SUBJECT: PLANS AND PROPOSAL ADDENDUMS
PROJECT: STP 2023 (675)MM CONTROL: 1433-02-044
COUNTY: COMAL
LETTING: 05/04/2023
REFERENCE NO: 0419

PROPOSAL ADDENDUMS

DESCRIPTION OF ABOVE CHANGES
(INCLUDING PLANS SHEET CHANGES)

8493-01UTL31-BGE.dgn
4/19/2023

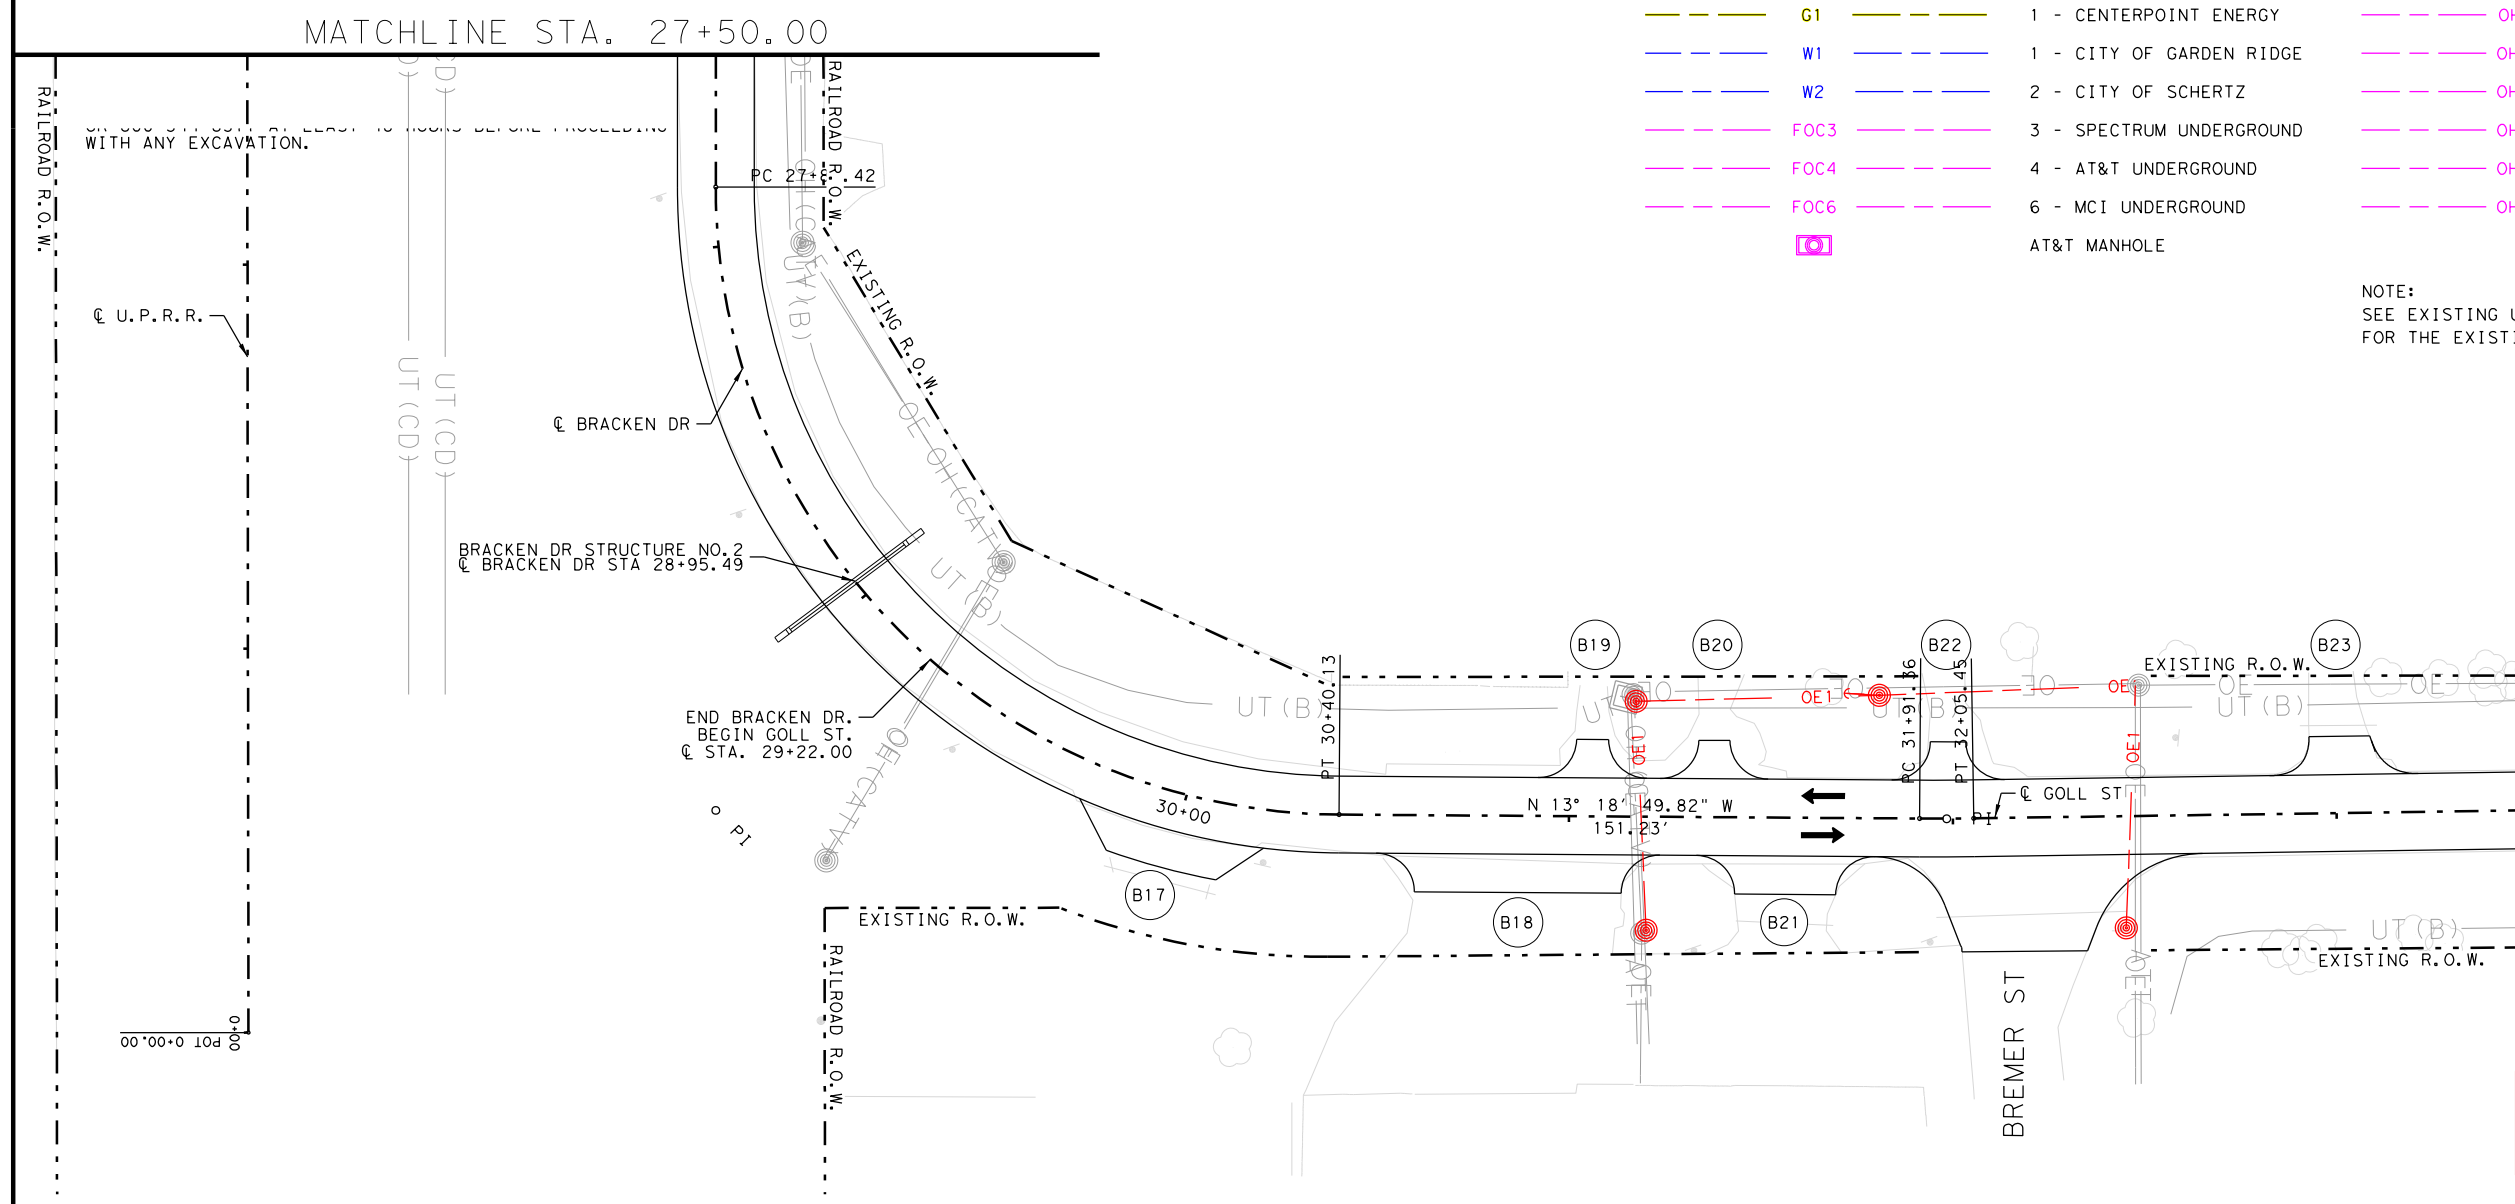
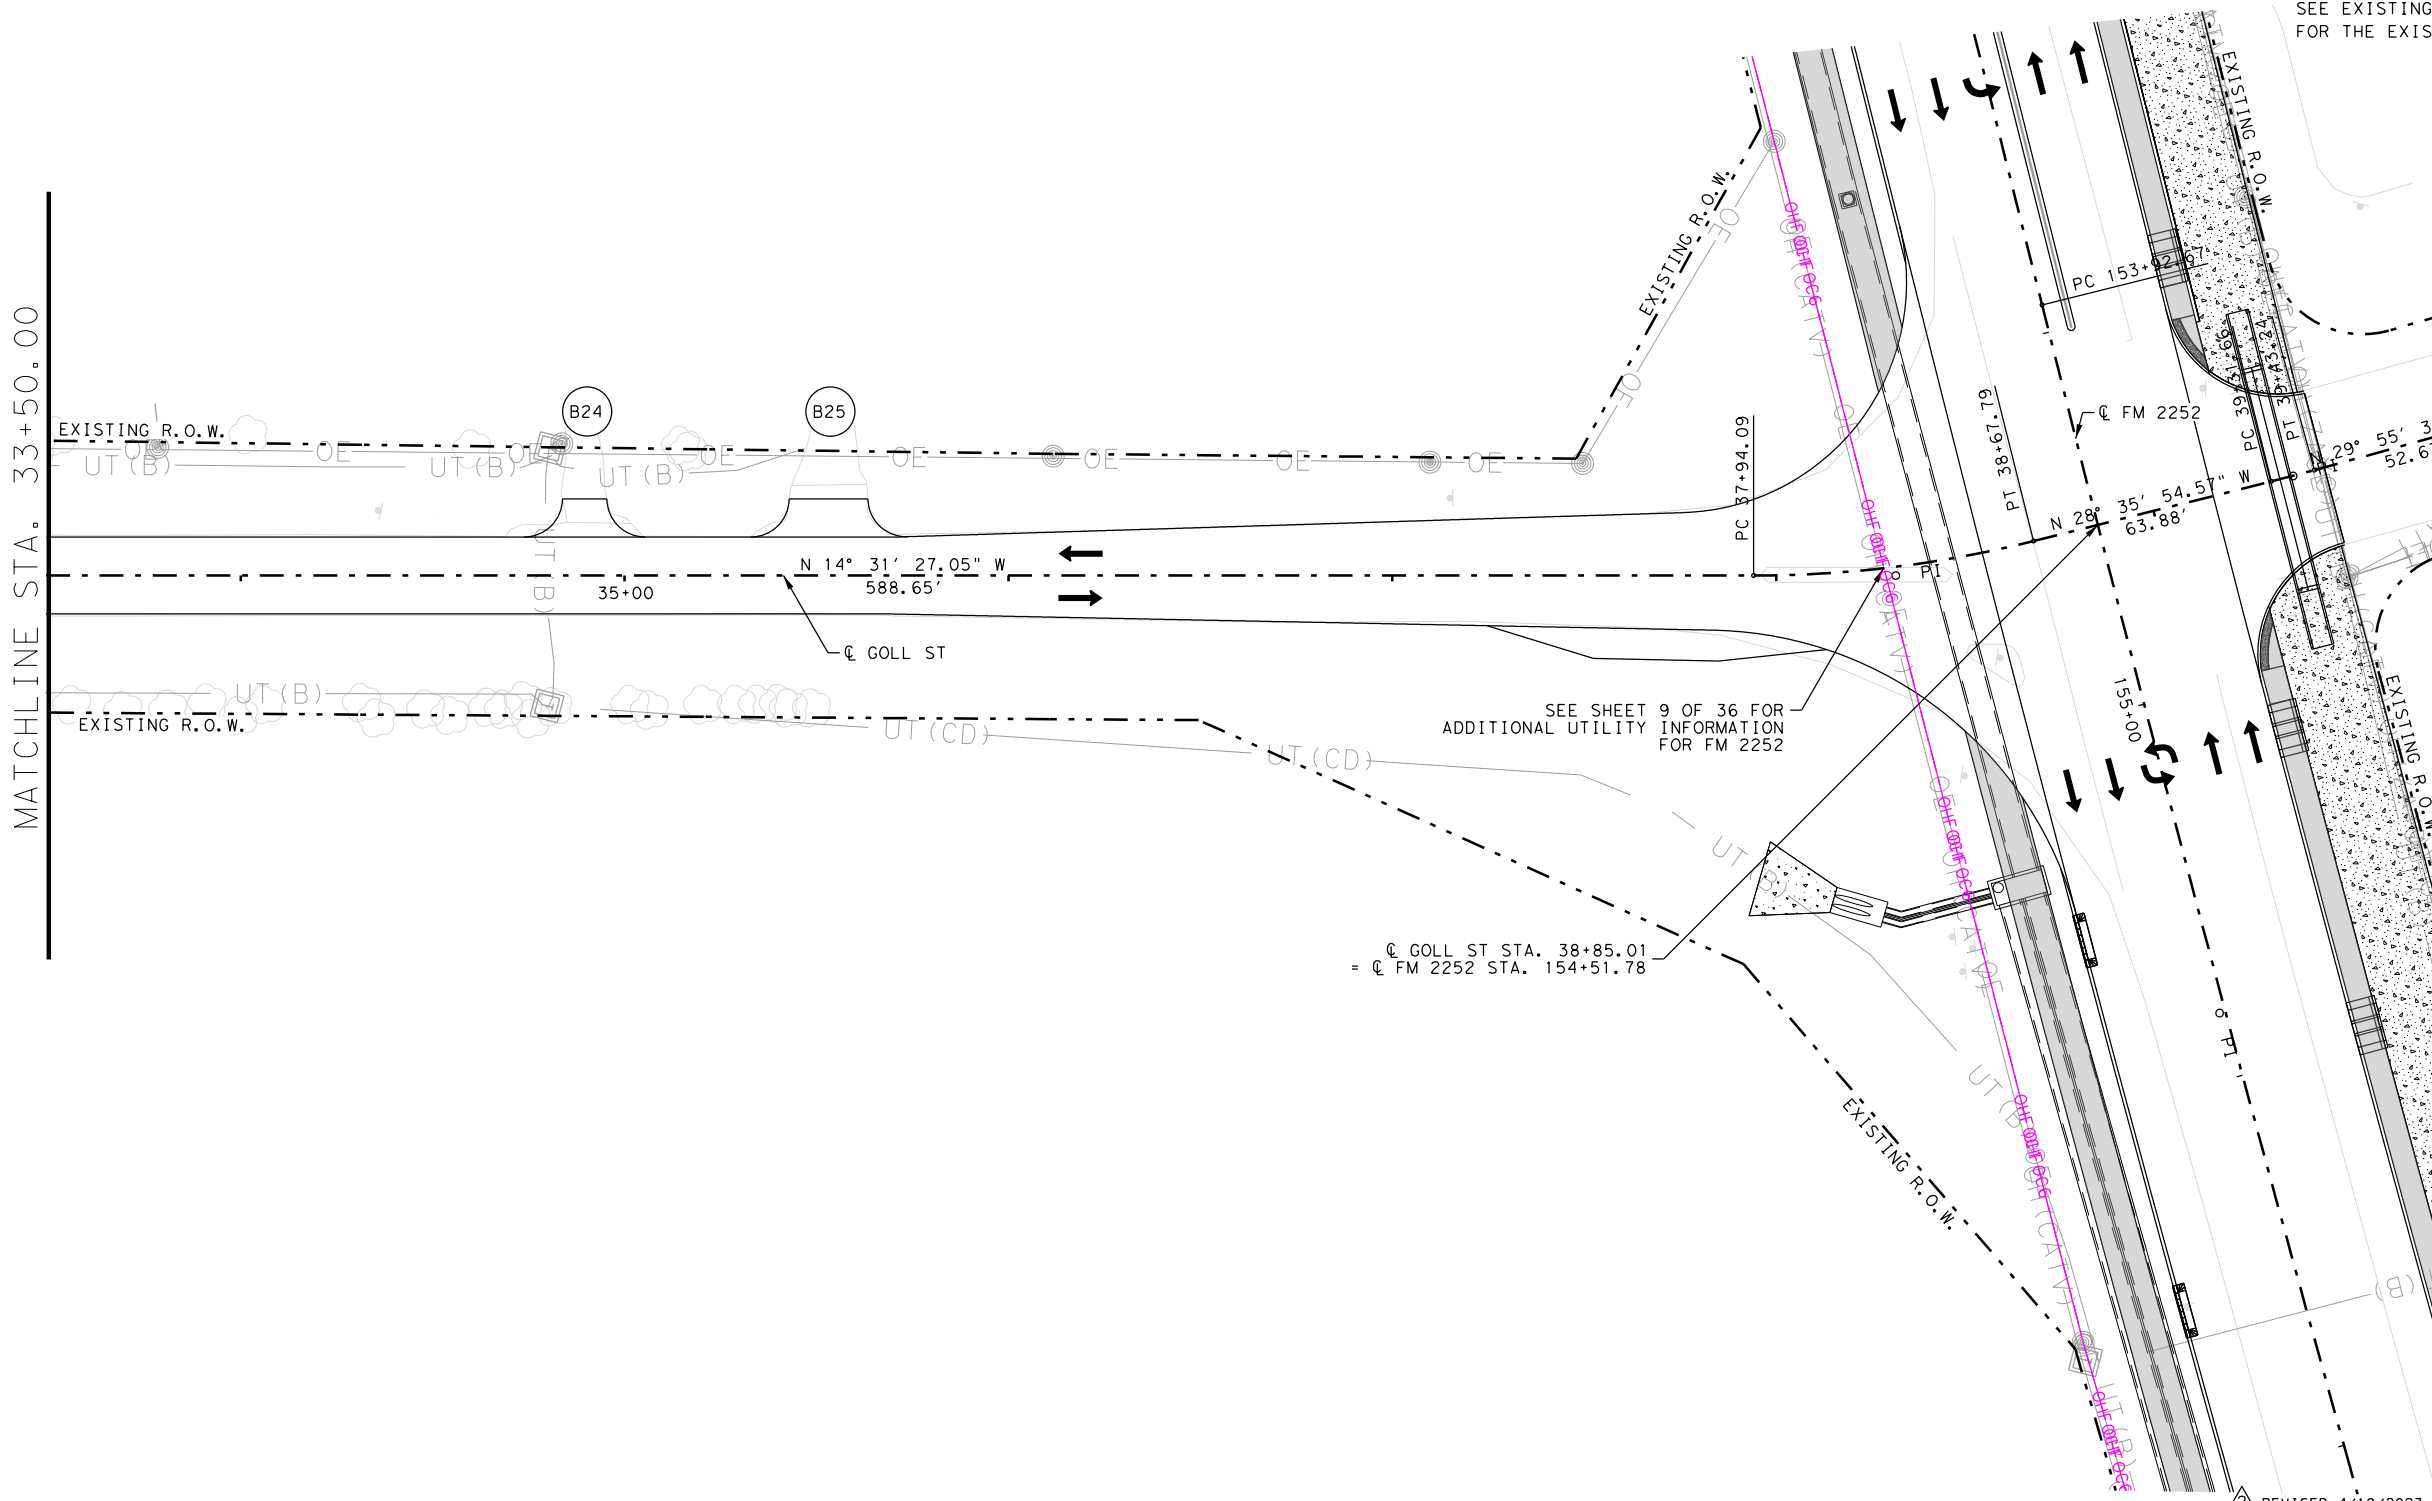
SHEETS 1330-1365: UPDATED UTILITY PLANS SHEETS LAYOUTS WITH CURRENT GAS
